SERVICE BULLETIN

Inspection, Check and Replacement of Hook Assembly P/Ns 505960-401 and 502737-459

ATA 25-20-01 and 25-10-01

SB505960-01, Issue: 5
Page: 1 of 13
Date: 06-Aug-2018

Figure 1 – Hook Assembly Without Exposed Springs

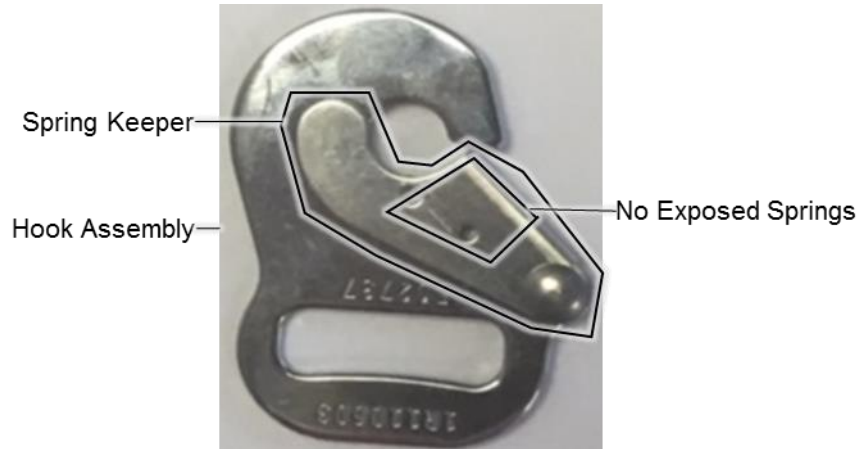
RC Step 3. Find the hook assembly (Figure 1 and Figure 2) on the connector half and the buckle half.

Step a. If the hook assembly on the connector half and the buckle half does not have exposed springs (Figure 1) you are done with this service bulletin.

Step b. If the hook assembly has exposed springs (Figure 2) proceed with this service bulletin.

Hook assemblies with exposed springs are subject to damage (e.g. compressed springs, bends, rotation or deformation).

Restraints without exposed springs (Figure 1) weigh 6 grams more than restraints with exposed springs (Figure 2).

This service bulletin ensures hook assemblies do not have exposed springs by providing the criteria and instruction to identify and replace restraints.

Figure 3 – Damaged Hook Assembly

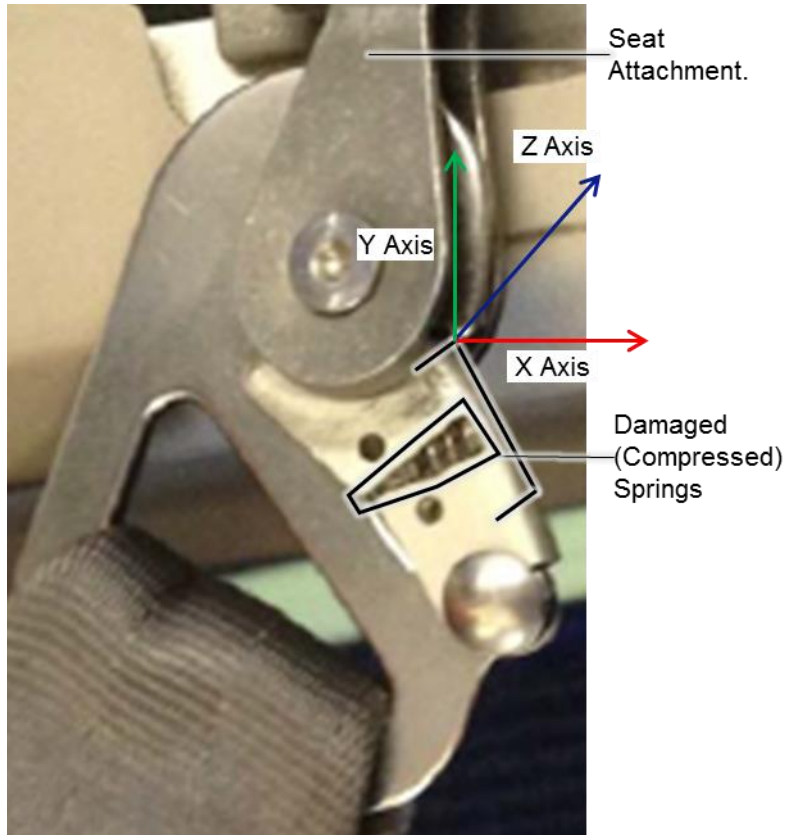
RC Step 2. Visually examine the hook assembly for damage (e.g., compressed springs, bends, rotation or deformation of the bridge along the X axis, Y axis or Z axis) that would restrict movement or function (Figure 3 and Figure 4).

Step a. If there is no evidence of damage the visual inspection is complete. Perform a functional check following the procedure in section 3.3.

Step b. If there is evidence of damage a functional check is not required.

Step i. Return the restraint to AmSafe by following the instructions in section 2.1 and by following the shipping and handling instructions in the ICA or CMM.

Step ii. Upon receipt of a new restraint from AmSafe, install the new restraint following the instructions in the ICA or CMM.

Figure 5 – Spring Keeper and Closed Loop

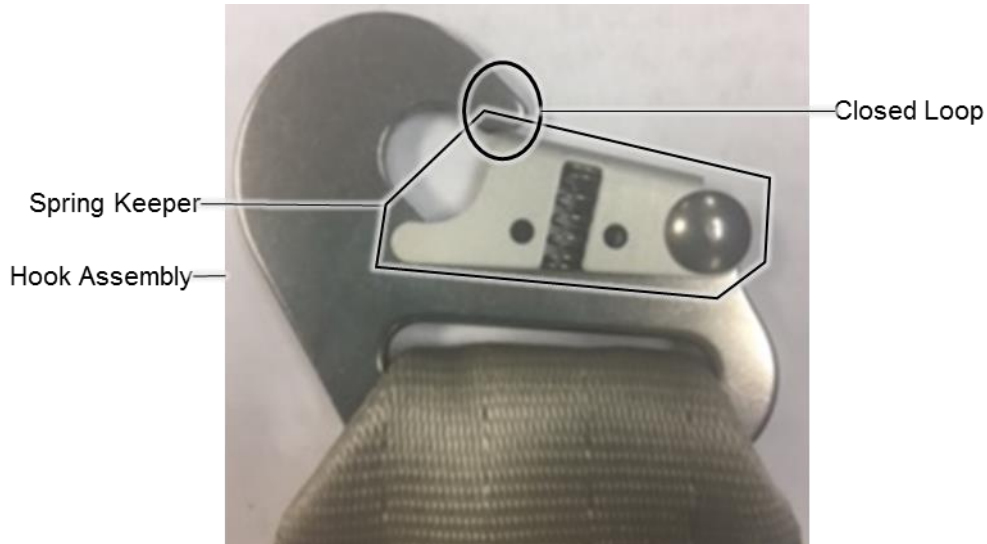
Step b. The spring keeper should return to a closed position. The closed position is achieved when the spring is firmly engaged/pressed and the keeper is against the hook, creating “closed loop” (Figure 5). There should be no deformation or damage preventing the spring keeper from returning to a closed position.

- Step c. If the spring keeper easily compresses and releases and returns to the closed position the functional check is complete.
- Step d. If the spring keeper does not easily compress and release, or the spring keeper does not return to a closed position, return the restraint to AmSafe.
- Step i. Return the restraint to AmSafe by following the instructions in section 2.1 and by following the shipping and handling instructions in the ICA or CMM.
- Step ii. Upon receipt of a new restraint from AmSafe, install the new restraint following the instructions in the ICA or CMM.
